# Measurement Method Proposal for self-adjusting reverse warning devices

TFRWS - 8th Session

### 6.4.2.

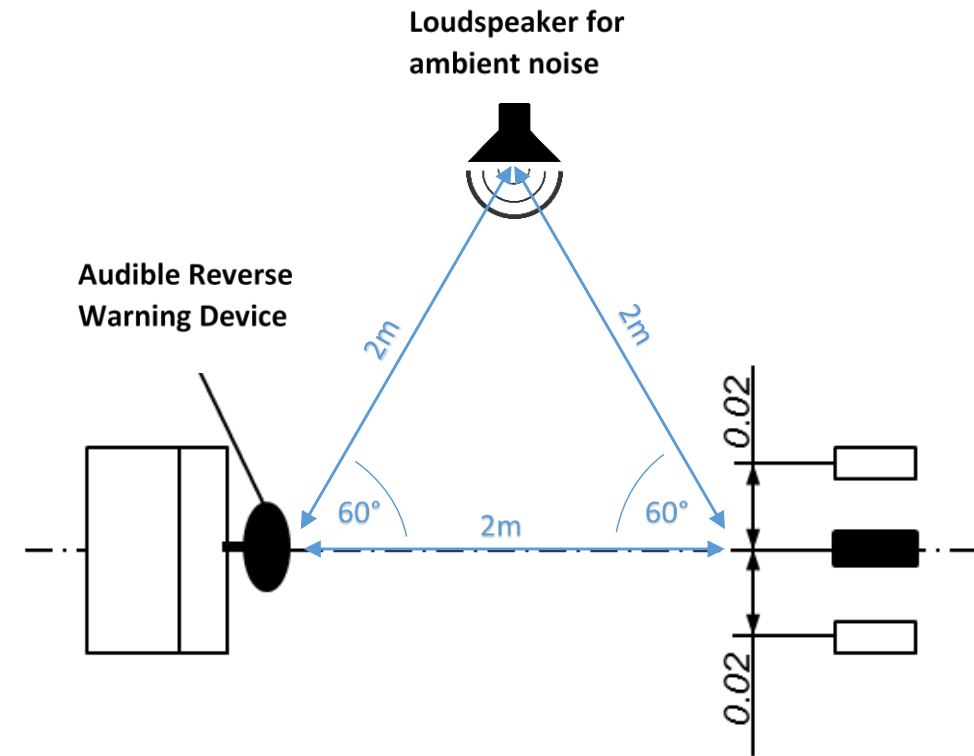
The audible reverse warning device to be tested, the microphone and the loudspeaker shall be placed at the same height. This height shall be  $1.20 \pm 0.05$  m. In alternative, the audible reverse warning device to be tested, the microphone and the loudspeaker may be placed in another traverse line which complies with Annex 3 specification for anechoic environment.

The microphone shall be so placed that its diaphragm is at a distance of  $2.00 \pm 0.05$  m from the plane of the sound outlet of the audible reverse warning device. The microphone must be positioned facing the front surface emitting sound of the audible reverse warning device in the direction in which the maximum sound level can be measured. The loudspeaker for ambient noise is placed at a distance of 2.00m from the audible reverse warning device and from the microphone, facing between the microphone and the audible reverse warning device.

See figure.

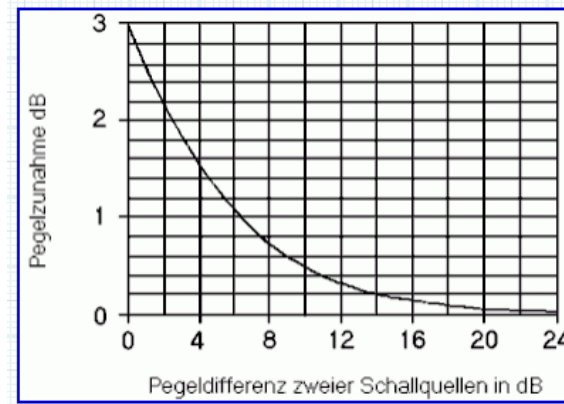
- A loudspeaker should simulate ambient noise. **Pink noise** is proposed because it is a common measurement signal, has a uniform temporal characteristic and its frequency spectrum is most similar to average ambient noise.
- The position of the loudspeaker should have the same distance to the microphone and the alarm. This ensures the same ambient noise level at both positions.
- SPL gain from the summation of the two signals (alarm and ambient noise) is negligible:  
The SPL difference is  $\geq 5$  dB  
therefore the gain would be  $\leq 1$ dB.
